**RE: 2205-178-SUB1-PLANS, 6454 East Mercer Way
Civil Plan Revisions per City Comments**

This letter accompanies revised civil plans in response to City comments of November 16, 2022. Each correction item is discussed below.

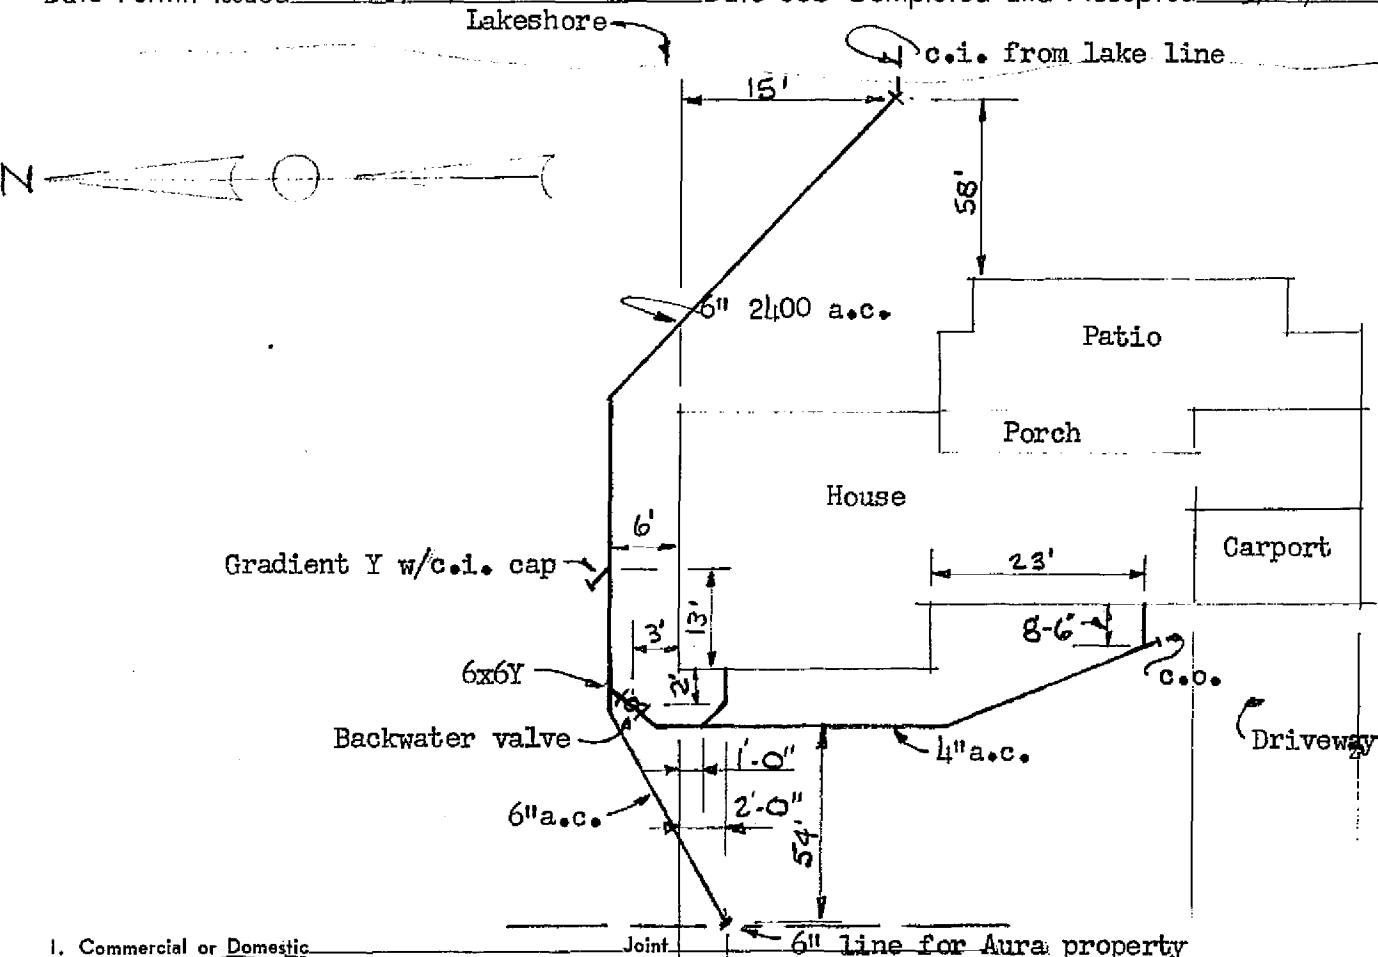
1. Arch. plan proposes a sewer backflow while civil plan calls out an existing one - which is it? Arch. site plan to remove side sewer info. A sewer backflow prevention valve is required if one does not exist.

According to the City sewer card (attached) there is an existing backflow preventer at the location shown on the plan. A note has been added to replace the preventer if directed by the City inspector. The preventer has been removed from the architectural plan.
